Product Change Notice for EKI-1526-BE and EKI-1528-BE

End of Life, Last Time Buy and Replacement Announcement

Product Part Numbers Affected by This Announcement

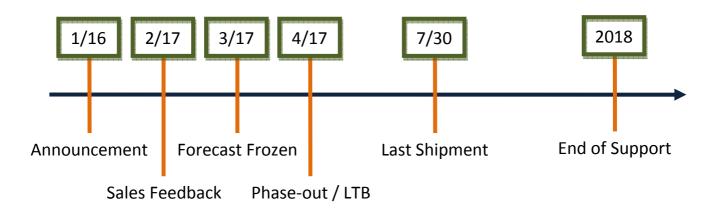
End of Life Product	Suggest Replacement Product	Sample Available Date
EKI-1526-BE	EKI-1526I-CE	Jan. 10, 2017
EKI-1528-BE	EKI-1528I-CE	Jan. 10, 2017
EKI-1526T-VDC-BE	EKI-1526TI-VDC-CE	Jan. 10, 2017
EKI-1528T-VDC-BE	EKI-1528TI-VDC-CE	Jan. 10, 2017
